## SSD 7054, LEES1 Building, Camperdown Campus

### Supplementary Information on Protection of Figs Fronting City Road

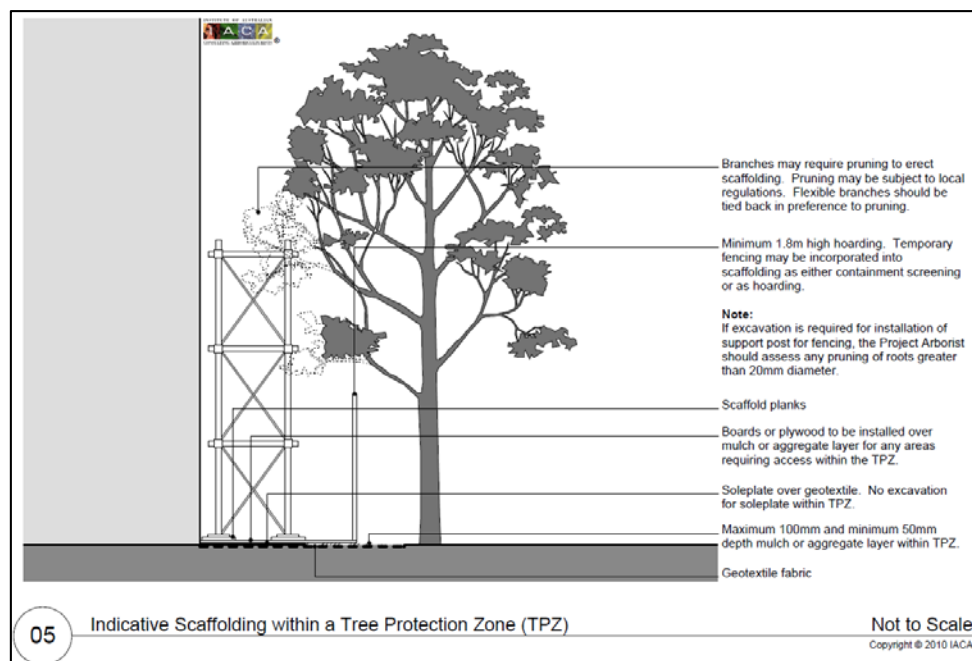
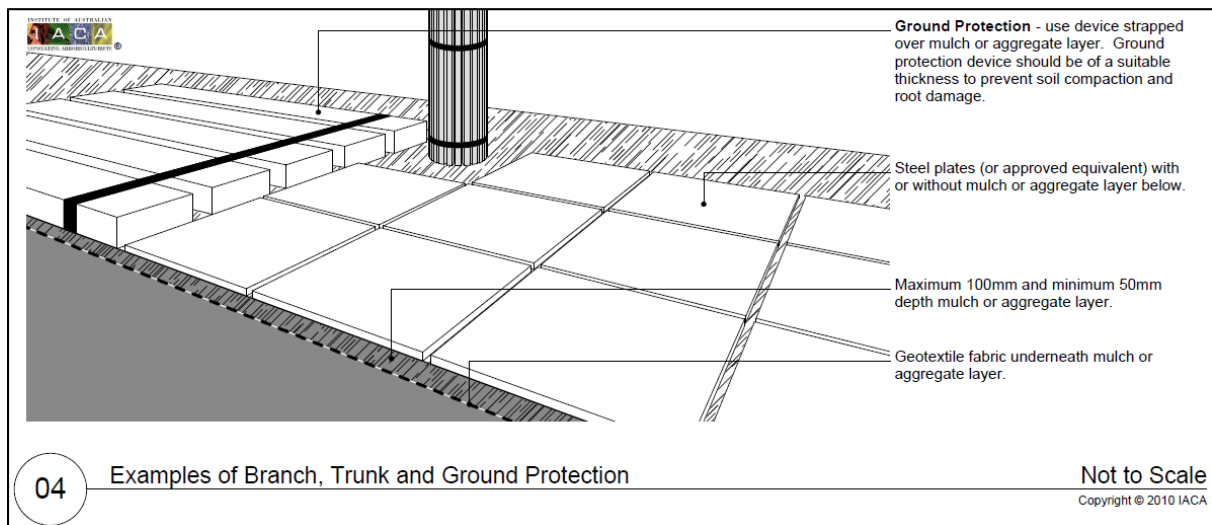
As per Section 3.6.7 of the Arboricultural Impact Assessment (Rev D, 11.04.16), any additional pruning in sections of the trees' upper crowns to accommodate sections of the proposed building projection will be limited to branches no greater than 50mm diameter. This pruning work should represent terminal growth only which could be either pruned with hand tools from hoardings/scaffolding or temporarily pushed back.

No additional pruning will be required for scaffolding or construction program of the LEES1 building.

Scaffold building edge section follows:

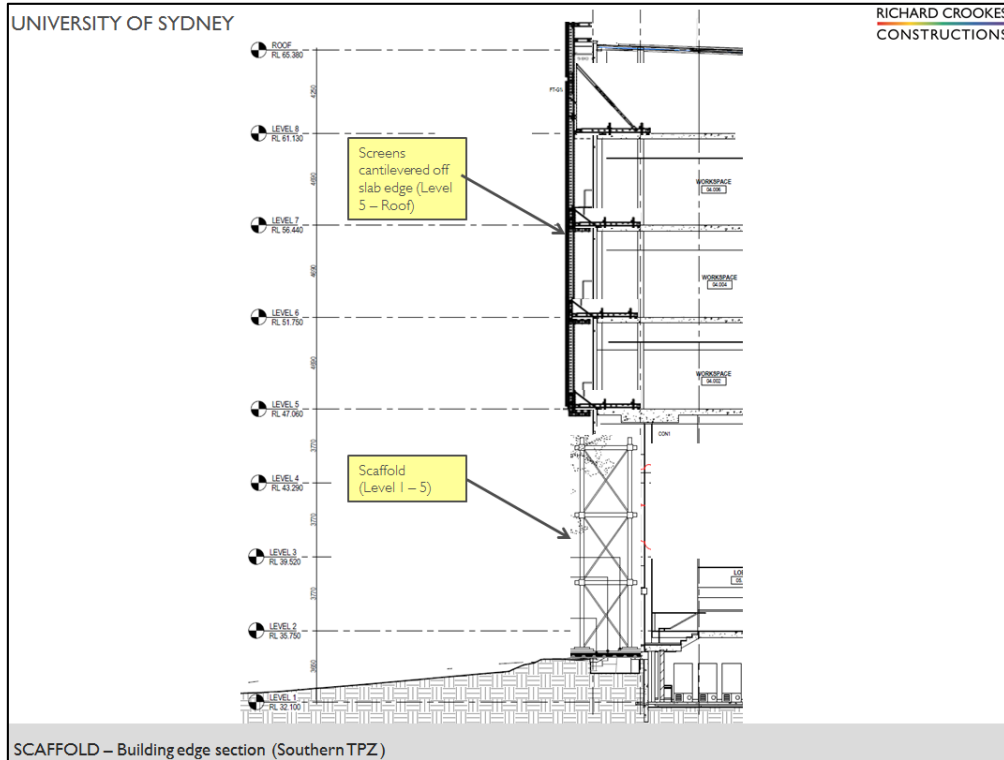
The proposed scaffolding will project approximately 2.0m from the final edge of the building façade, extend from Ground Level to the underside of Level 5; above this level proprietary screens will be utilised which are supported on the as constructed slab edge (not ground

level) and extend approximately 700mm from the final edge of the building. The scaffolding design is flexible and can be modified as necessary to limit additional pruning requirements or prevent damage to the trees.

Excerpt photo of screen edge protection proposed for Level 5-Roof as follows:

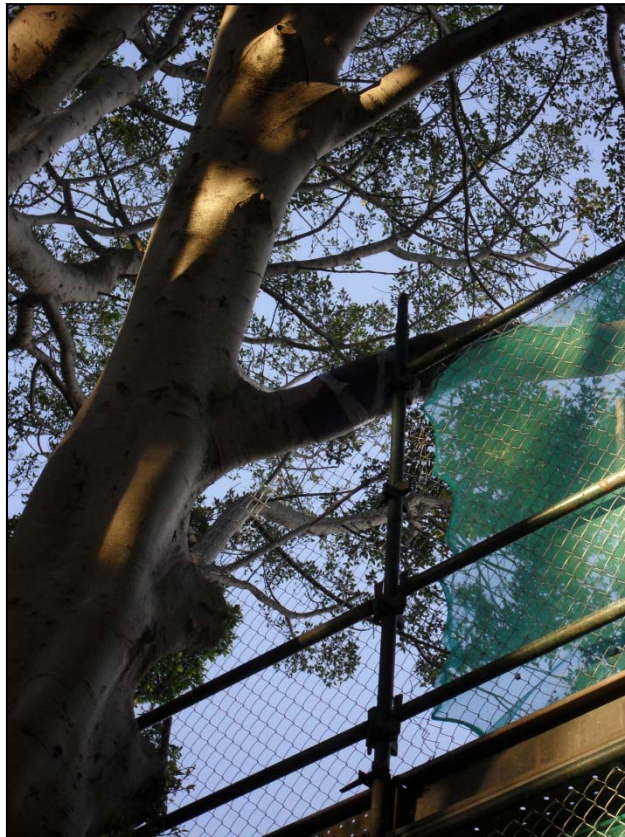
Prior to removal of the scaffold from Level 1-5 the external façade will be finished, utilising the existing scaffold, including finish coating of façade surfaces, glazing and soffit installation.

After final casting of the reinforced concrete super structure and installation of the upper level structural steelwork the screens from Level 5-Roof will be removed and the prefabricated curtain wall will be installed by lowering in to position utilising the site crane. Any access requirements after curtain wall installation shall be undertaken utilising rope access or the site crane (man box).
